ADDENDUM NO.1

PROJECT: Loxley Transit Hub Pavilion
FTA/EWSMPO 5307 Funded Project
Loxley, AI
WHLC Project # 21-205

ARCHITECT: WHLC Architecture
70 South Section St Suite 4
Fairhope, AI 36532

5 WINDOW SCHEDULE
SCALE: 1/4"=1'-0"

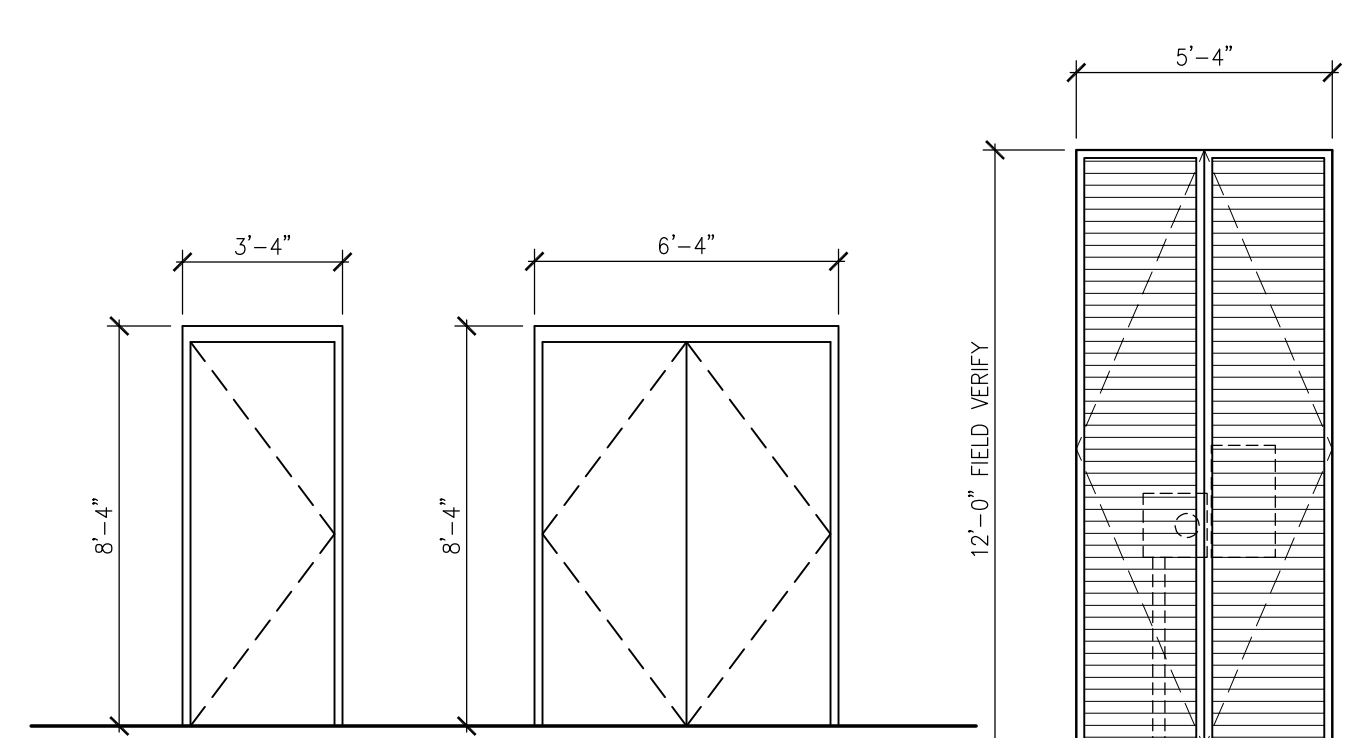
1. What is on page 34?
Sheet A2.00 which is attached to this addendum.
2. Is there a door and window schedule?
Sheet A2.00 which is attached to this addendum.
1. Is the GC responsible for applying and purchasing the bldg. permit through the city?
Building Permit Fees will be paid for by the owner
2. Same question for trade contractors?
Mechanical/Electrical/Plumbing permit fees will be paid for by the owner.
3. Is the GC responsible for tap fees?
Yes
4. Per sheet C04 the saddle and valve and the bore for both water and sewer is by LPW. Is this work to be performed by LPW as well?
Yes
5. Electrical contractor is responsible for bore, NOT LPW, correct?
Contractor responsible for electrical bore
6. Are there liquidated damages on this project? If so, how much?
Liquidated damages are \$750.00 per day
